EAGLE MOUNTAIN CITY

City Council Staff Report

NOVEMBER 18, 2014

Project:	**Gateway Park**
Applicant:	Scot Hazard
Request:	*(1)* Rezone areas of the property to Business Park and Commercial Storage
	(2) Master Site Plan
	(3) Preliminary Plat
Type of Action:	Public Hearing; Action Items
Planning Commission:	Recommended Approval (5-0) w/ conditions

MASTER SITE PLAN

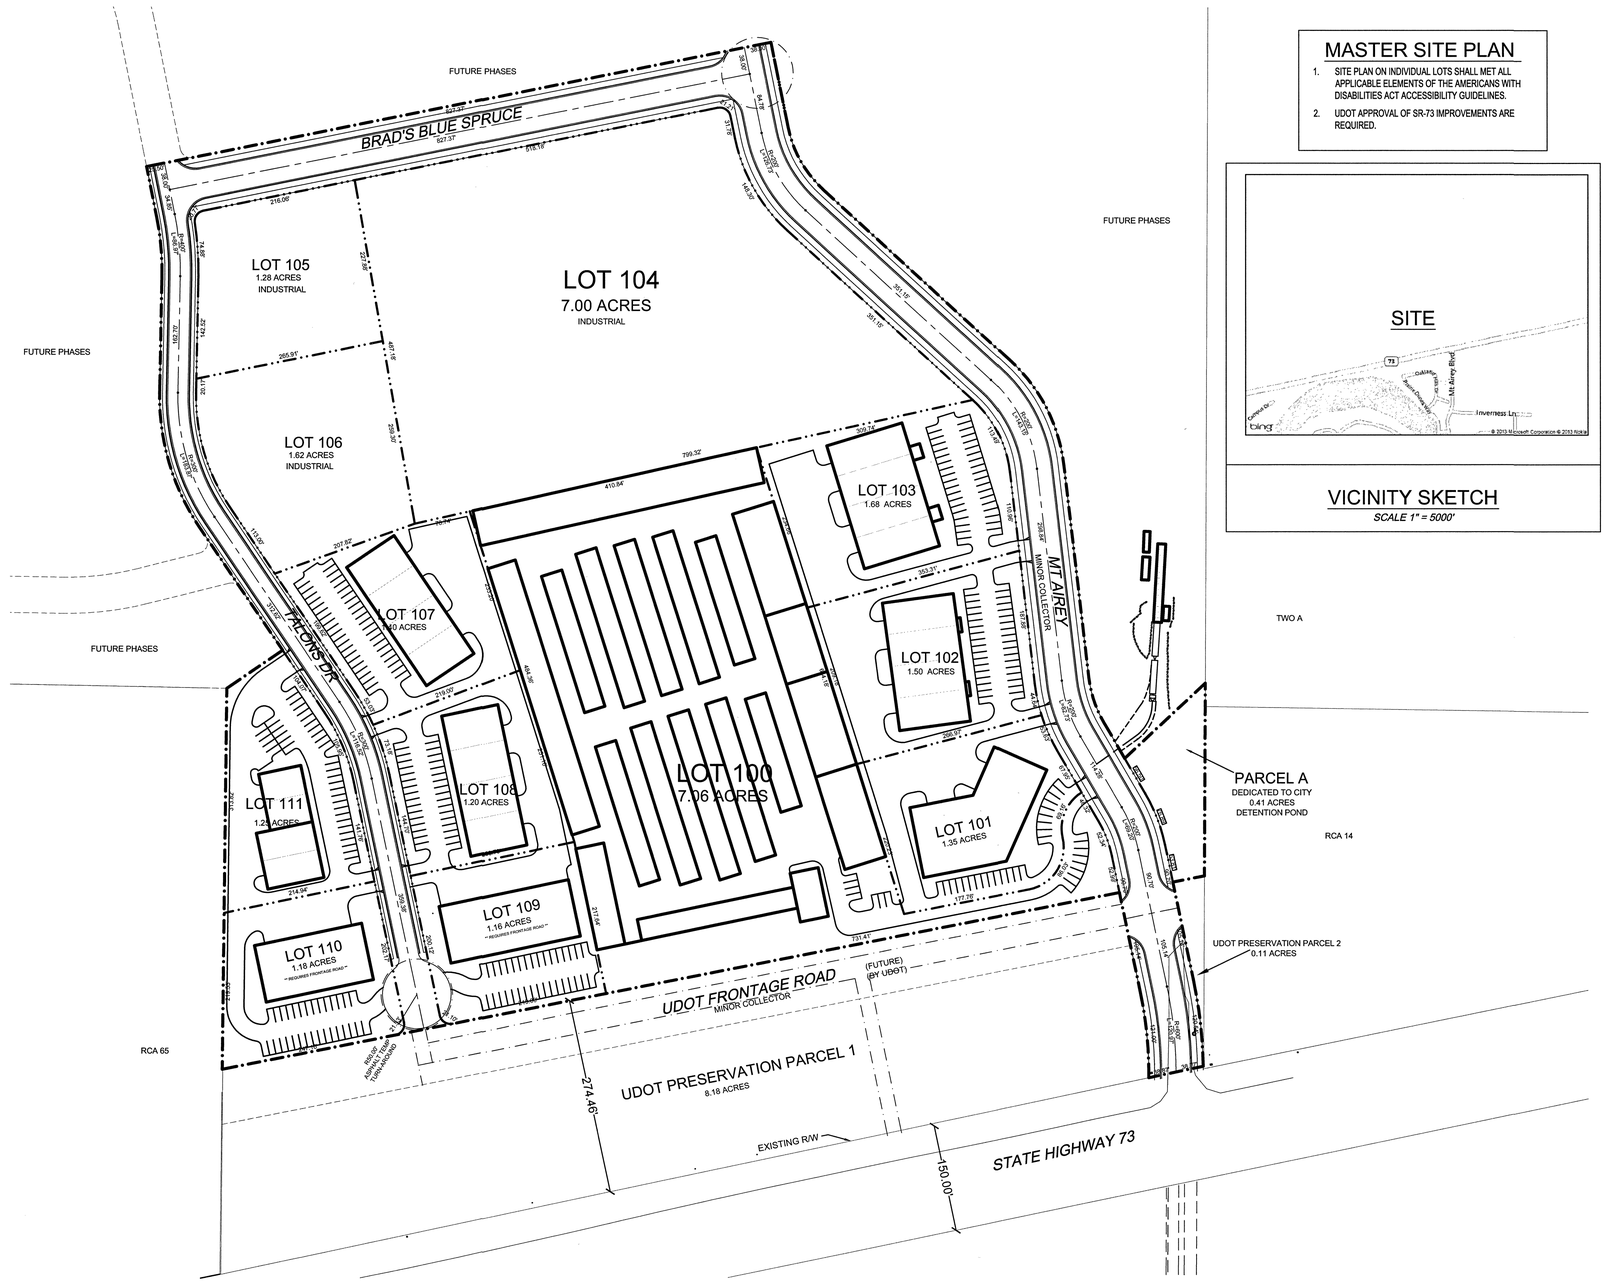
A conceptual master site plan has been submitted showing a potential layout of the buildings and parking. Since this specific use is different than standard retail or office, there may be a need to consider some alternative parking arrangements. The buildings and lots, for instance, could be redesigned to contain parking on the sides of the buildings rather than the front. This would likely result a different number of buildings than proposed. If you feel inclined to approve the proposed conceptual master site plan with the parking between the street and the buildings, then it should be clear that the landscaping treatments in this area should be fairly extensive, with shrubs and berms for headlight screening, trees, etc. You should also consider amending the City Code Chapter 17.72 Multi-Family and Commercial Design Standards to address office-warehouse uses.

Again, this site plan is conceptual only and does not vest the developer with any specific building or parking layout. An individual site plan approval is required for every lot in this development prior to development. Some uses will require a conditional use permit as well. Final plats are also required.

- Storage Unit Access. The access for the storage units is awkward, putting trucks in conflict with parking for lot 101. While it is located away from the main intersection, it provides an awkward entrance. This should be reevaluated with the first final plat and individual site plans.

- Truck Access. The gravel pit trucks will be accessing this roadway at the place designated on the proposed plan. This provides potential conflicts with business traffic. The access is improved from the original plan, but still provides some concern.

- The layouts of the buildings and parking are conceptual only, and do not comply with the commercial design standards. These will have to be evaluated with each individual site plan.

1. *Individual site plan approvals are required for each lot. Landscaping, architecture, parking and building layout will be reviewed at that time.*

SHEET NAME	SHEET NUMBER
PRELIMINARY PLAT	C1

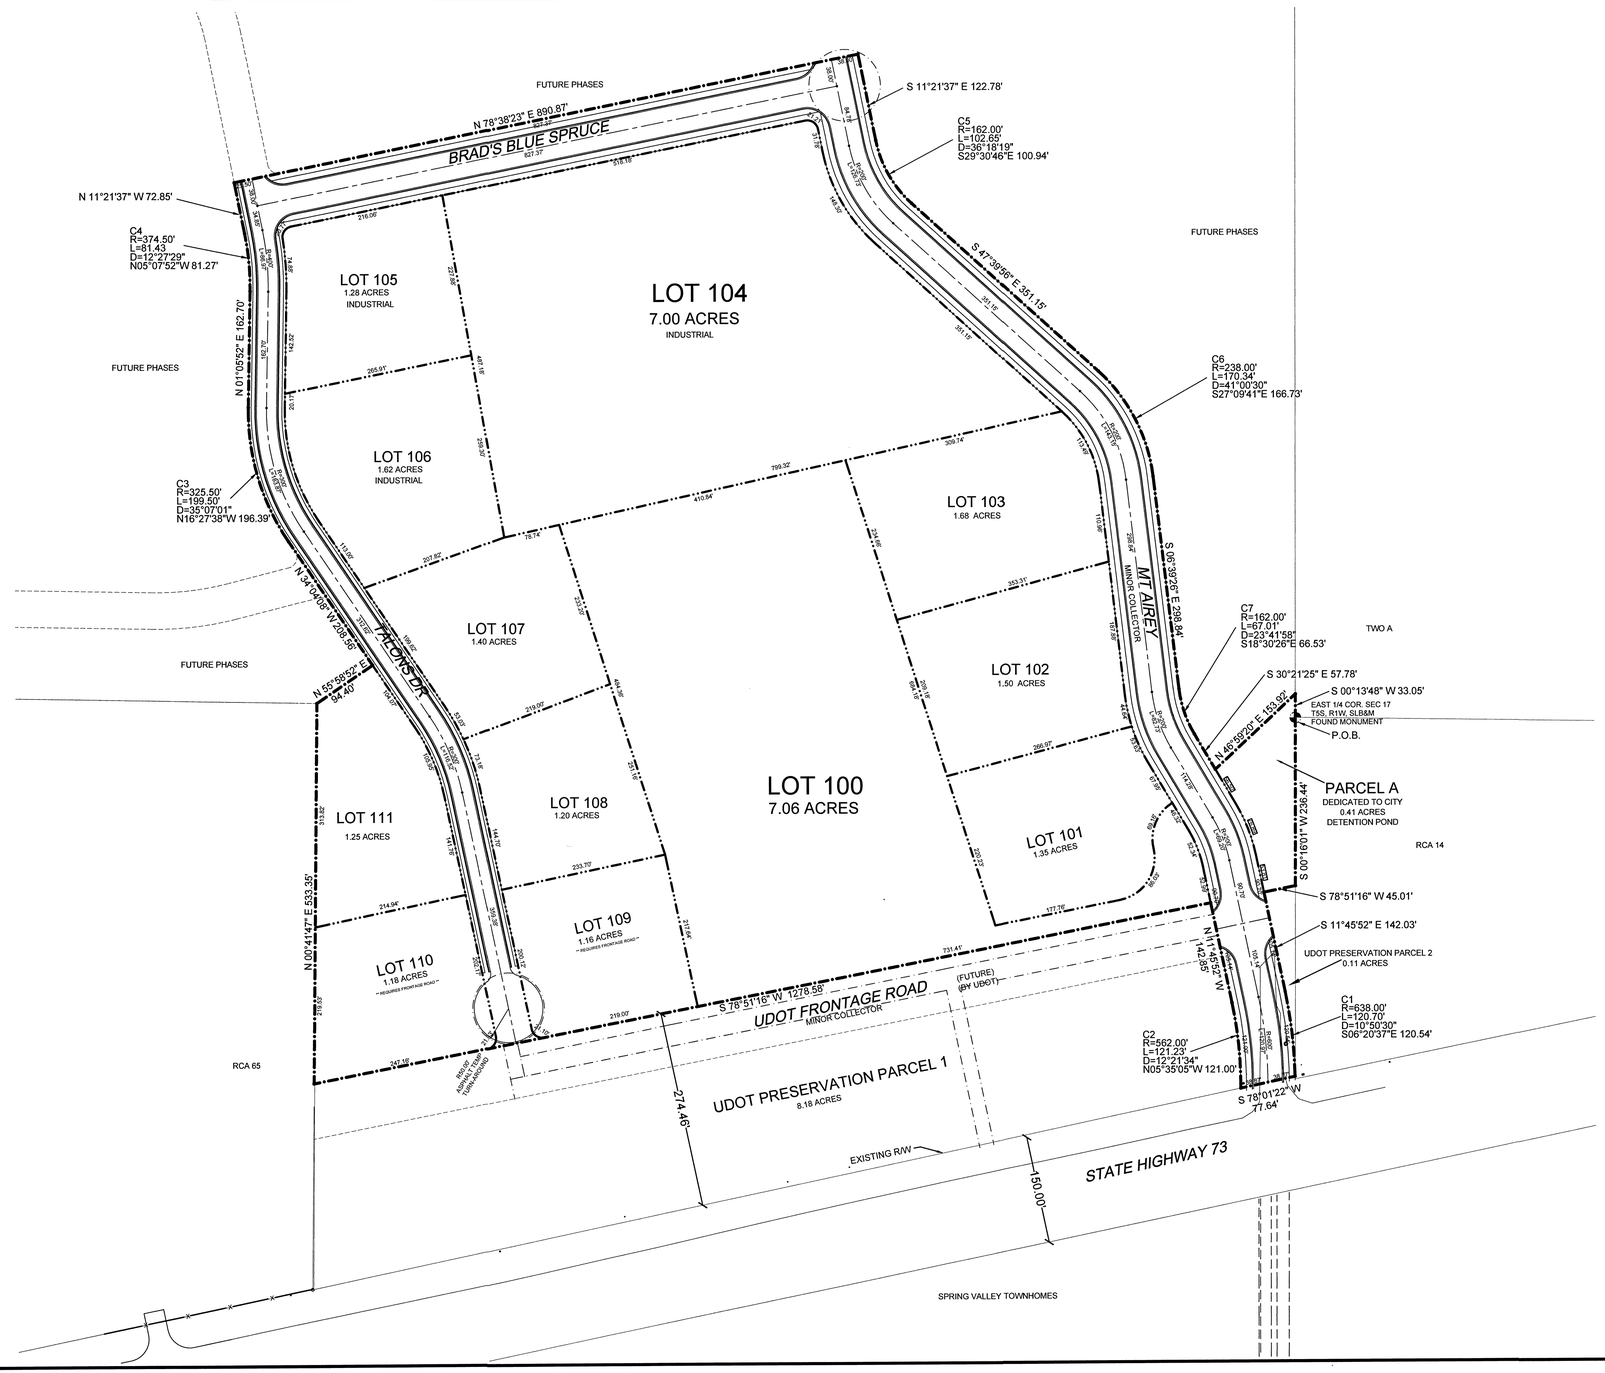
UDOT is planning to expand SR73 (aka Cory Wride Memorial Highway) in the next 10 years to become a freeway, similar to the eventual build out of 2100 North in Lehi, with freeway in the middle and 2-lane one-way frontage roads along each side. Lots 109 and 110 contain notes on the preliminary plat that state "Requires frontage road." According to the Fire Marshal, all of the western lots (lots 105-111) will require a second access to Ranches Parkway, the constructed UDOT frontage road, or SR73, unless given a special approval by the head Fire Marshal.

- Any dead-end road beyond 750 feet requires special Fire Marshal approval or a second access.
- The natural drainage patterns of the property must be handled appropriately to the satisfaction of the City Engineer.

1. *Developer must provide a water model for the project and must comply with any requirements as a result of the water model.*
2. *A second access is required for construction or permits for lots 105-111, unless approved by the Fire Marshal.*
3. *Storm drain calculations and plan must be approved by the City Engineer.*
4. *Developer must provide an access agreement with UDOT for utilities located within UDOT right-of-way or install utilities outside of the UDOT right-of-way.*
5. *All offsite sewer will need to be installed prior to construction of phase 1. Provide offsite sewer design with the first final plat.*
6. *A detailed sign plan is required with the first site plan, including details for an entryway monument for the project. The entryway monument must be completed with the first final plat.*
